Appendix I Community Involvement and Agency Coordination after Draft EIS Publication

Agency Comments and Project Team Responses

Re: Tier 1 Draft Environmental Impact Statement for the South Bridge Connector Project, Brown County, Wisconsin, CEQ No. 20200128

OU3
COMPLETED REMEDIAL ACTION

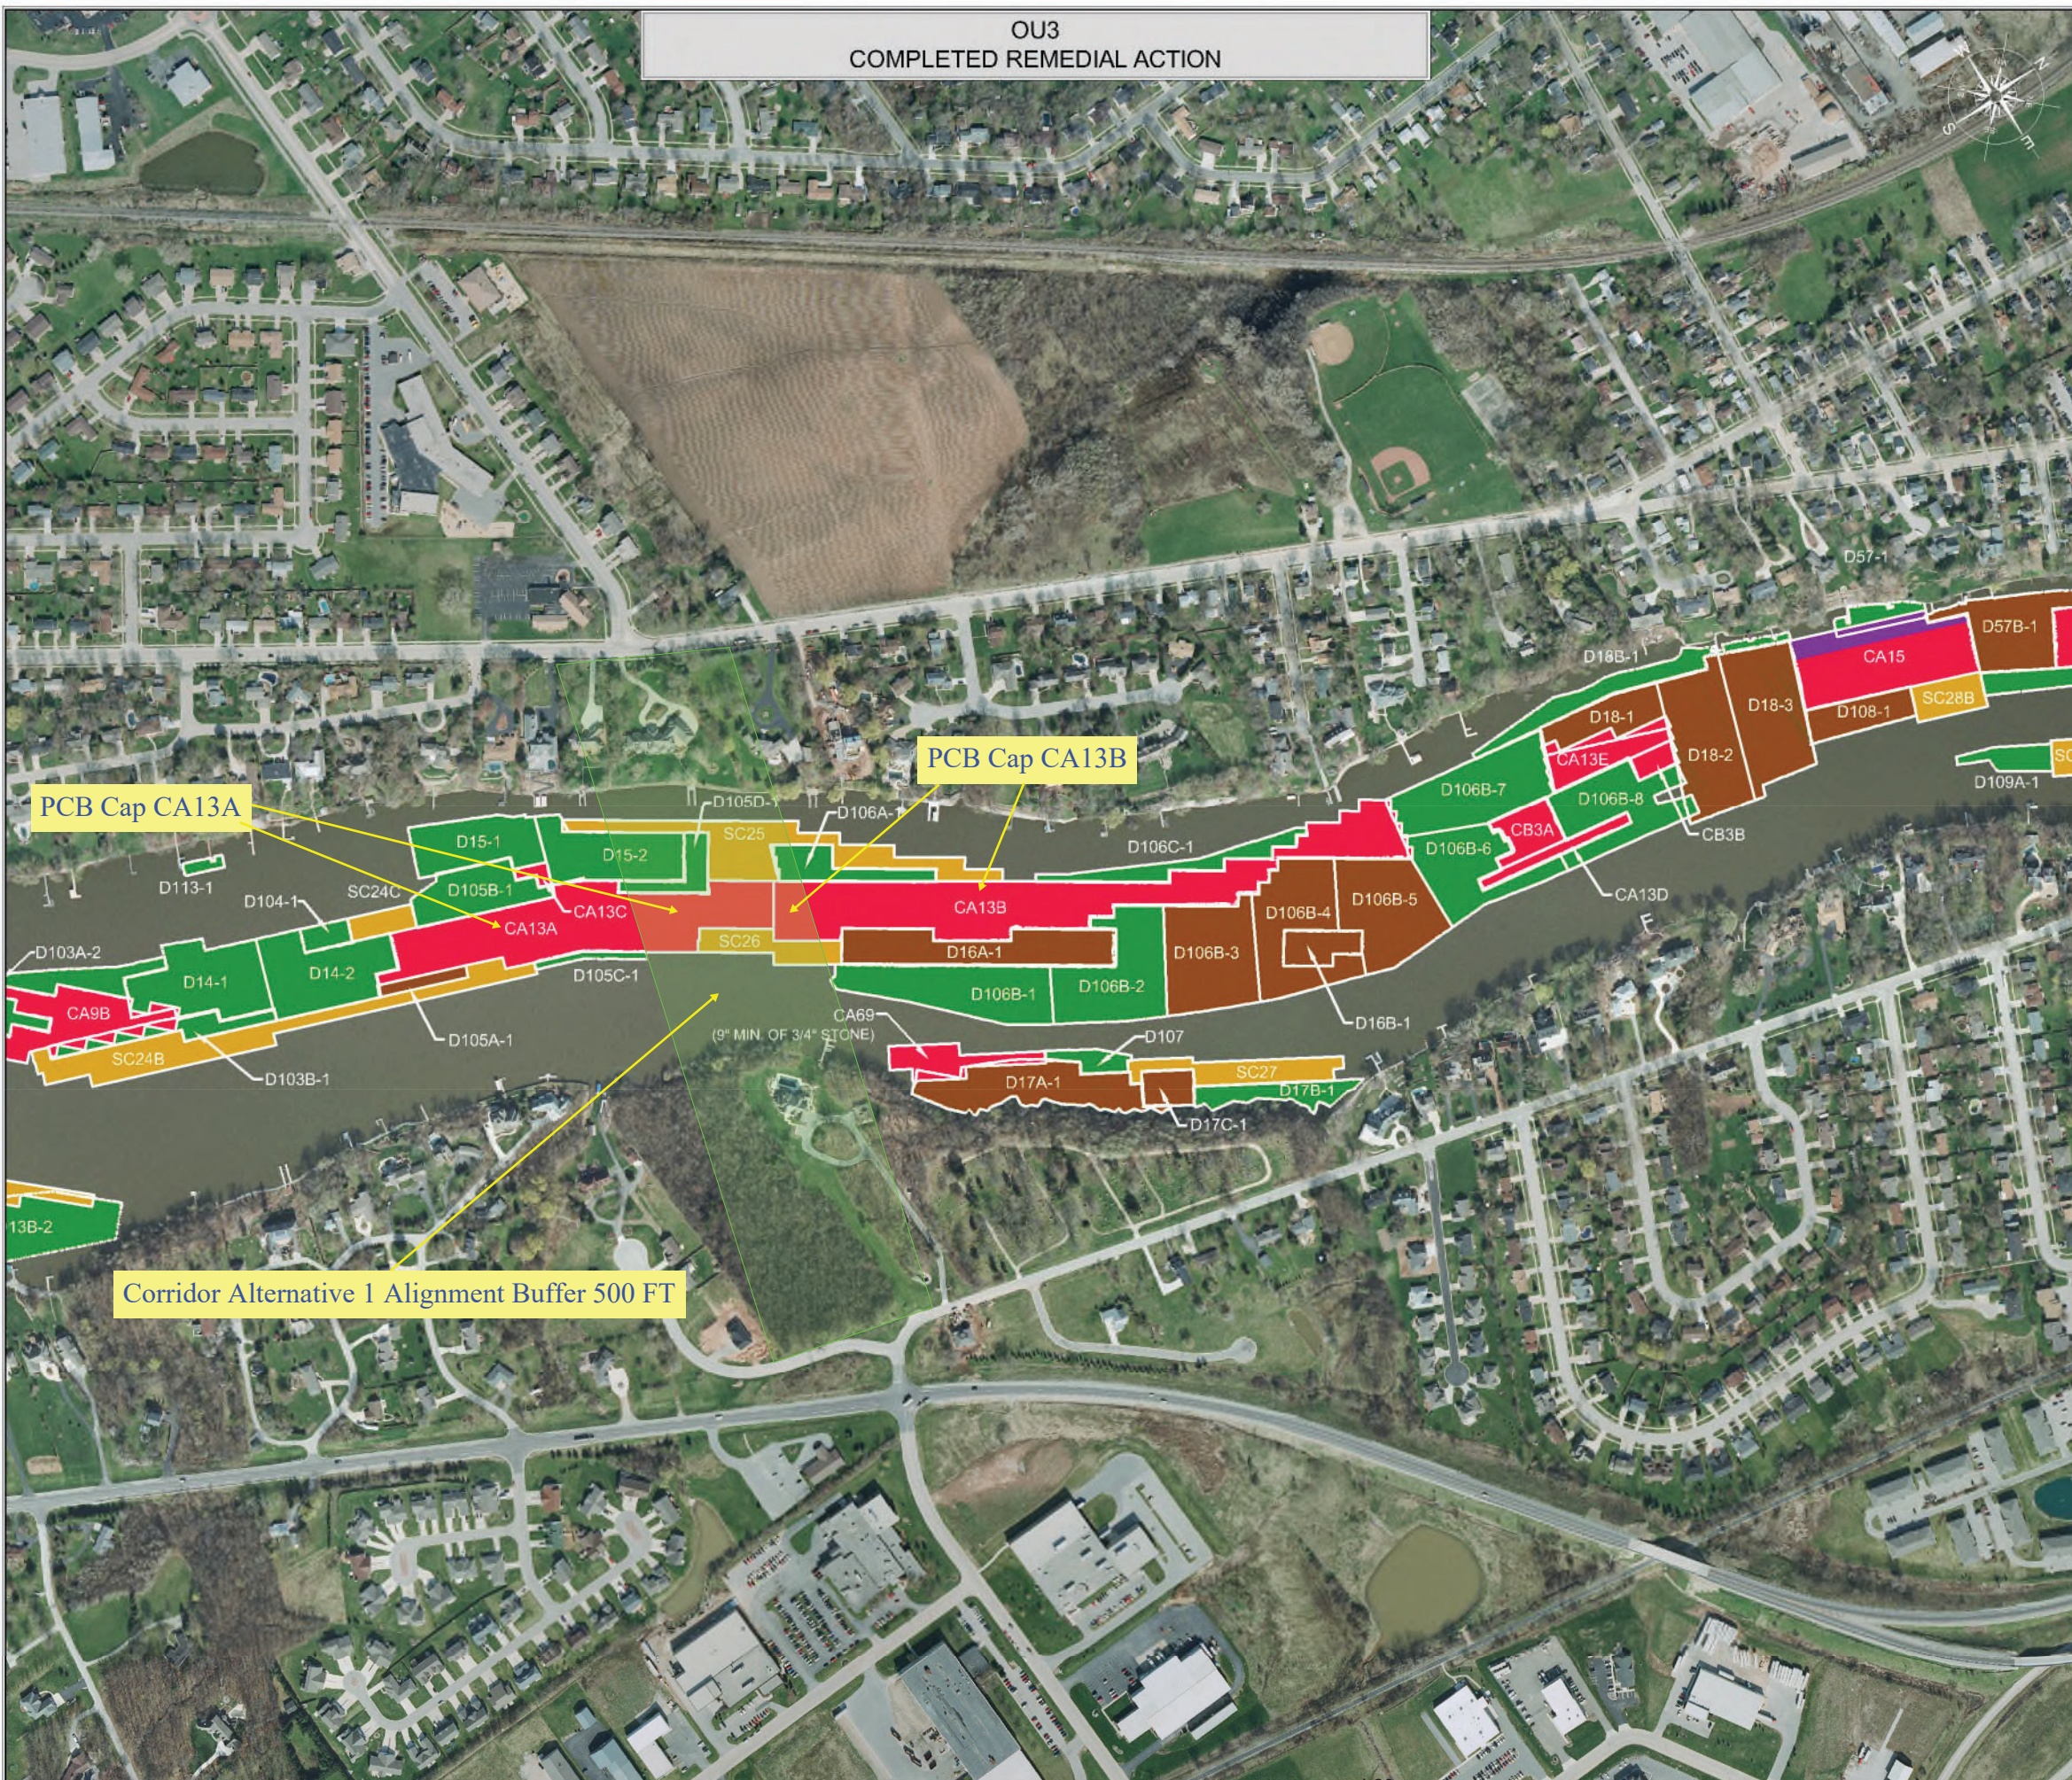
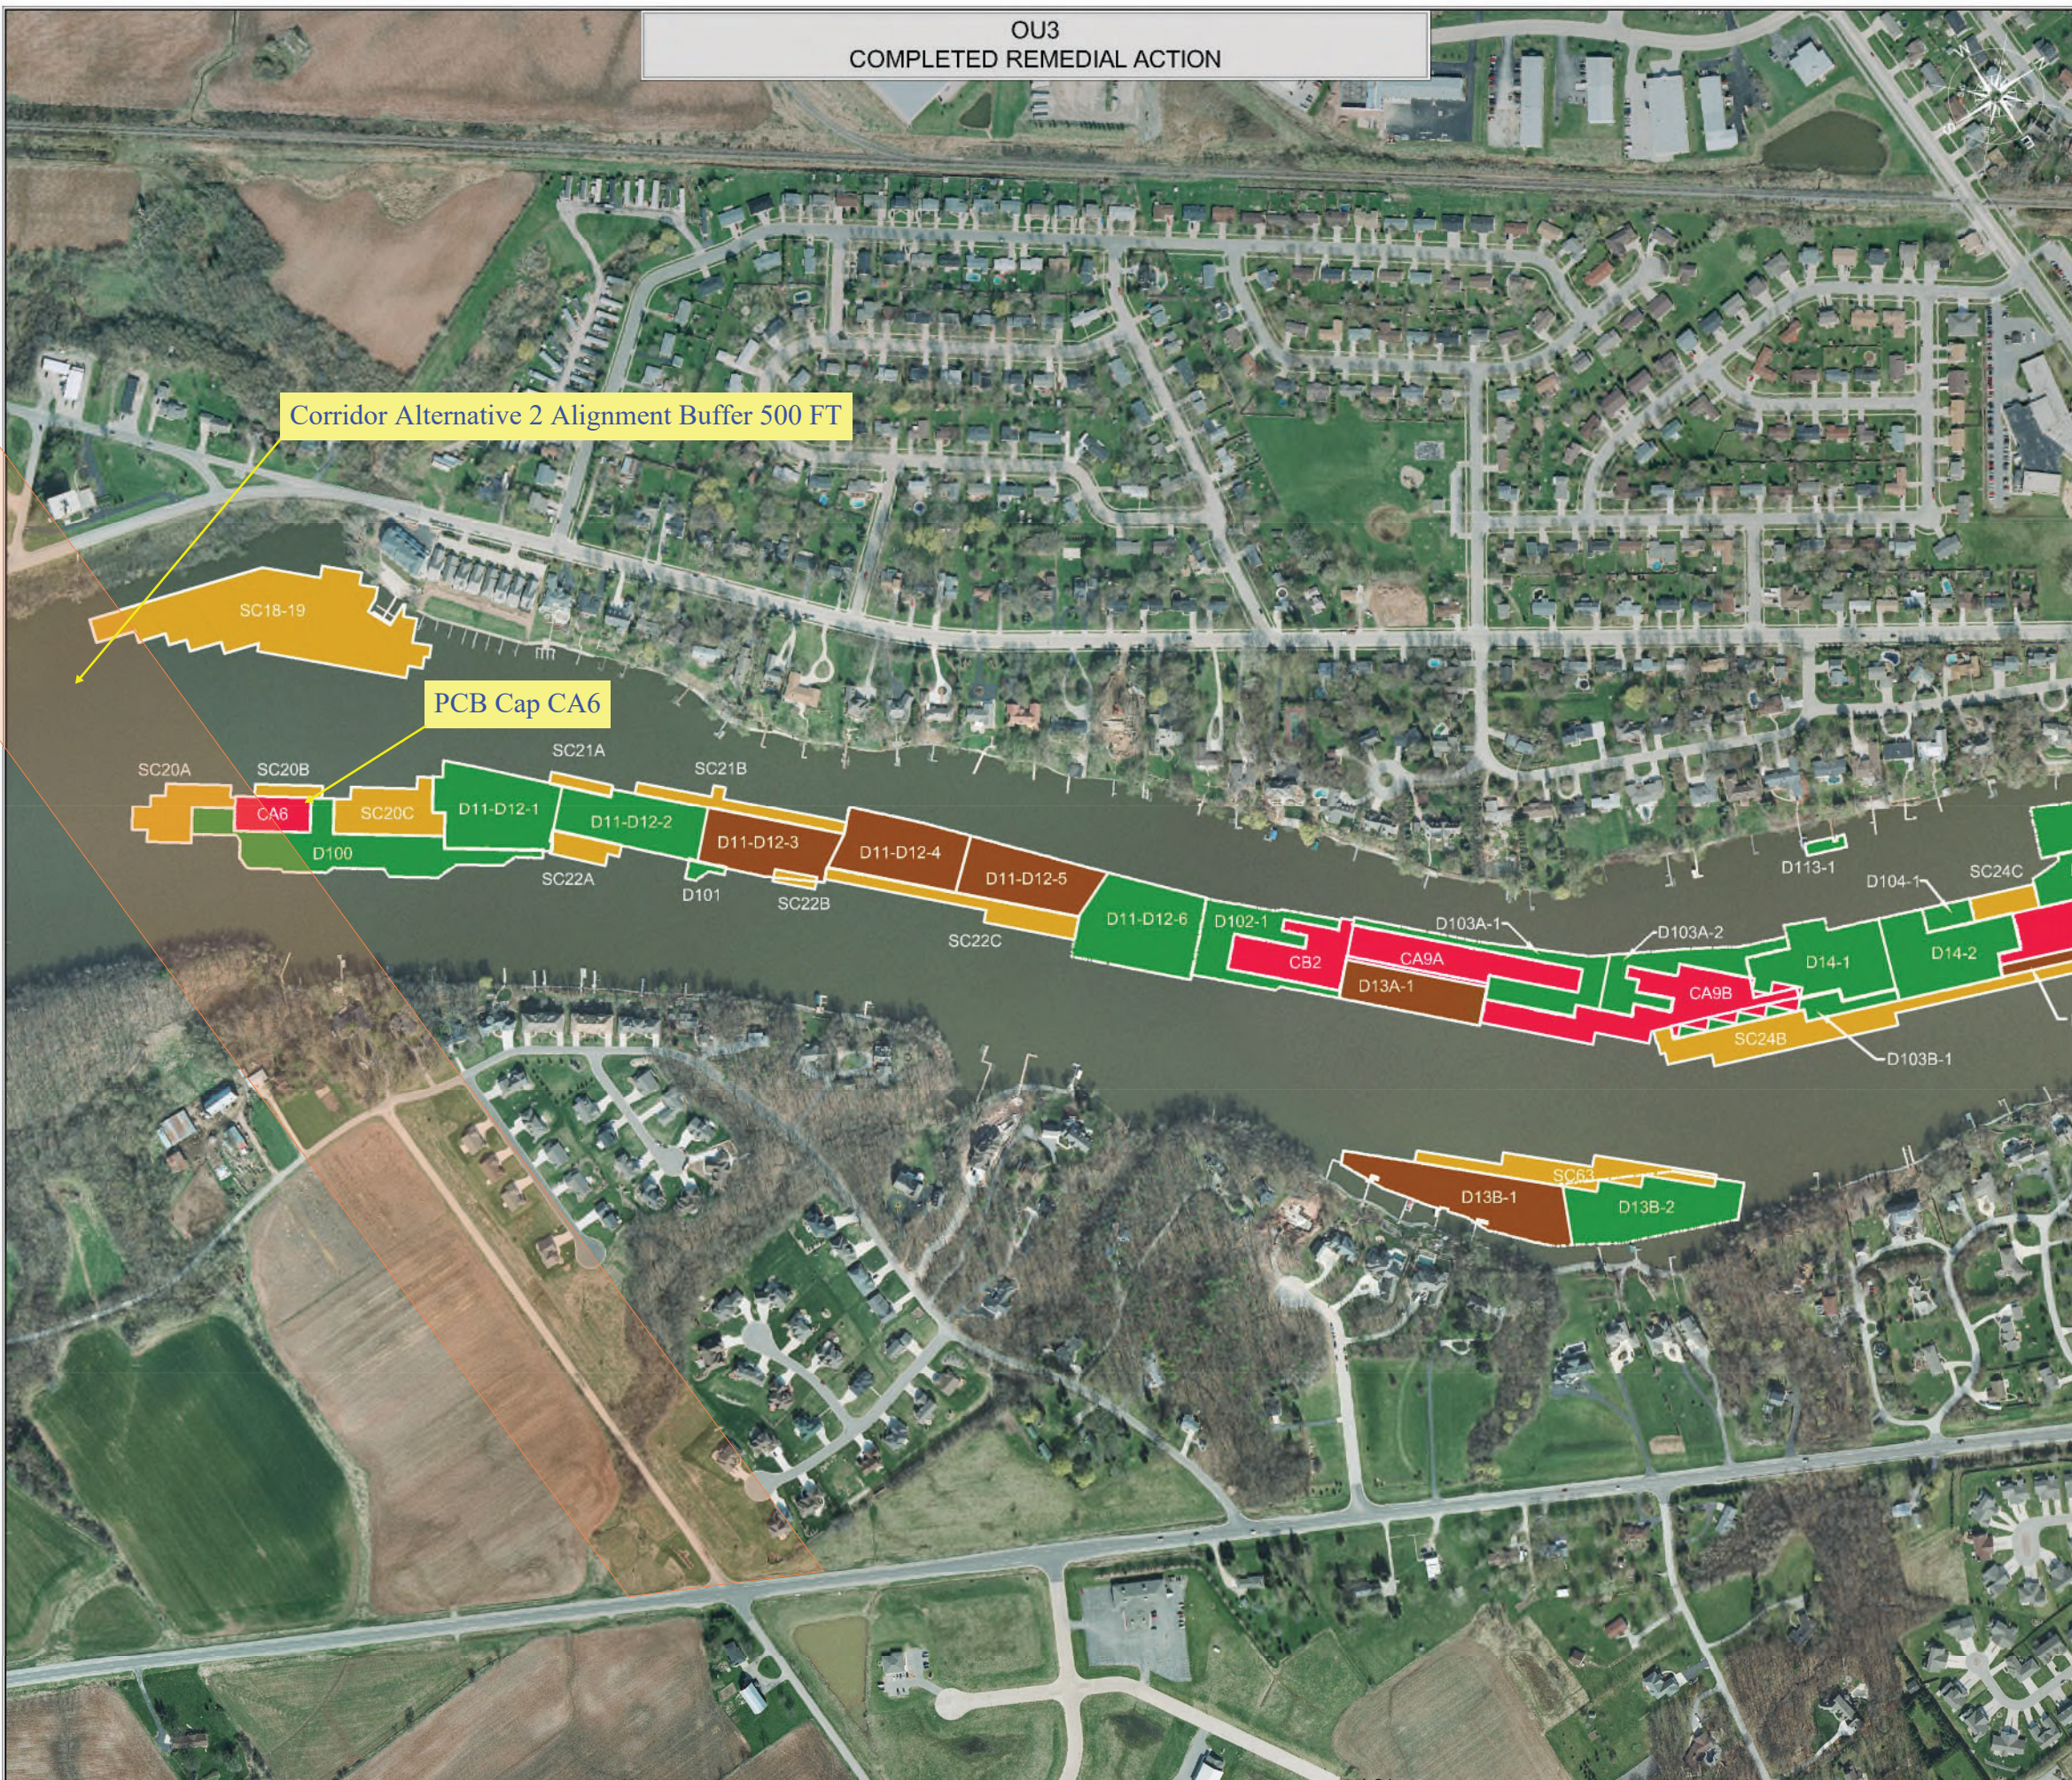
8.	There should be some discussion of wildlife and fisheries impacts as well and impacts to the Fox River and the Lower Fox River PCB cleanup efforts (e.g., engineered cap impacts). See attached file (Location of Corridors and PCB Caps in LFR.pdf). There is also a 24-inch water intake siphon line structure near Alternative Corridor 2 to be considered. See attached file (Siphon Intake Line for Alternative Corridor 2.pdf).	Information was added on impacts to wildlife and fisheries. Information was also added, concluding that Corridor Alternative 2 would have less impact on the Lower Fox River cleanup efforts because it crosses fewer capped areas containing contaminated sediment than Corridor Alternative 1. Information on the Siphon added to Section 3.9, Water Resources. Impacts to the siphon are not anticipated
